Docket No. 50-423
B15064

Millstone Nuclear Power Station, Unit No. 3
Inservice Inspection Program - Relief Request from
Performing Volumetric Examination of Inner Radius
of Steam Generator Main Steam Nozzle

Millstone Nuclear Power Station, Unit No. 3
Relief IR-19, Inner Radius of the Main Steam Nozzles

Relief Request: IR-19

LAST NUMBER USED	4628006
ITEM	1
QTY	1
DATE	11.1.57
BY	
CHECKED	
APPROVED	
Westinghouse Electric Corporation	
TAMPA DIVISION TAMPA FLA.	
APPARATUS STEAM GENERATOR MODEL "F"	
TITLE STEAM CHUTE NOZZLE COOLING	
6524039	
DRAWING SET TO SCALE SHEET NO. 1 OF 1 SHEETS

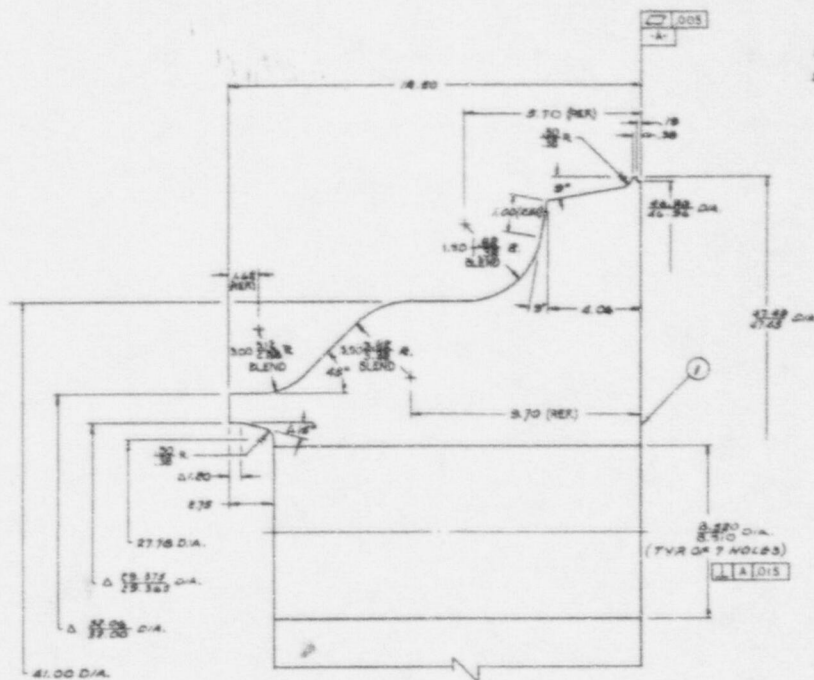
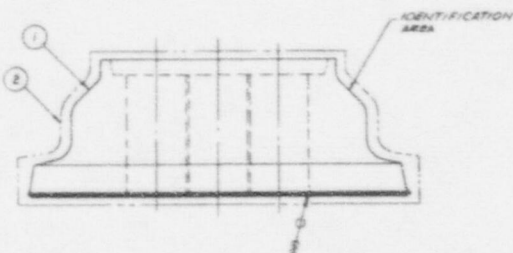
NNECO believes that, in evaluating the above referenced ASME Code, the concern is that the inside radius of the four Main Steam Nozzles are considered susceptible to flaw initiation and growth due to high thermal and mechanical stresses associated with the vessel and connected piping systems. In the case of the Millstone Unit No. 3 steam generator nozzles, the nozzle is a one-piece forging containing a set of seven holes bored parallel to the nozzle centerline (refer to figure). NNECO believes that this nozzle design does not fall under the criteria of a "radiused

nozzle" as defined in Figure IWC-2500-4 (referenced above). Since the ligaments between the holes distribute the loads throughout the nozzle forging, the primary stress resulting from pressure is significantly lower than the expected for a typical nozzle inner radius region. The thermal stresses for this type of nozzle are also lower than those for a typical nozzle since the plate ligaments provide both reinforcement and additional insulation by directing the flow away from the nozzle inner radius. Furthermore, the local stresses resulting from the thermal gradients in the inner radius are expected to be low since the nozzle is only exposed to saturated steam resulting in a low heat transfer between the nozzle and the coolant.

NNECO will perform visual examination during system leakage tests as required by Section XI and Code Case N-498.
